Access Compliance Report Public Rights-of-Way (Curb Ramps)

Main Street: RISILLA_ST		Cross Street: GALANTE_ST		Location:	SW
ADA ID: RPRK211119131816	Ramp Type: Type 4 - Parallel	Initial Pass/Fail: Fail	Overall Compliance: No	Severity Score:	19
Codes/Mitigation Info/Possible Solution			Field Measurements/Component Compliance

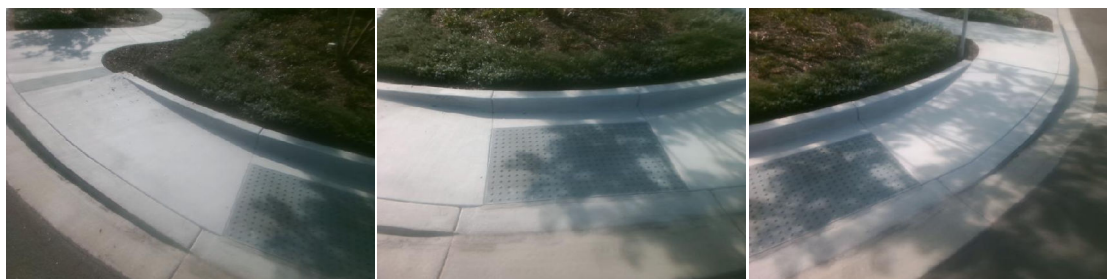
R304.5.1, R304.3.2, STD 1115

Remove & Replace Curb Ramp With Two New Directional Ramps or Equivalent.
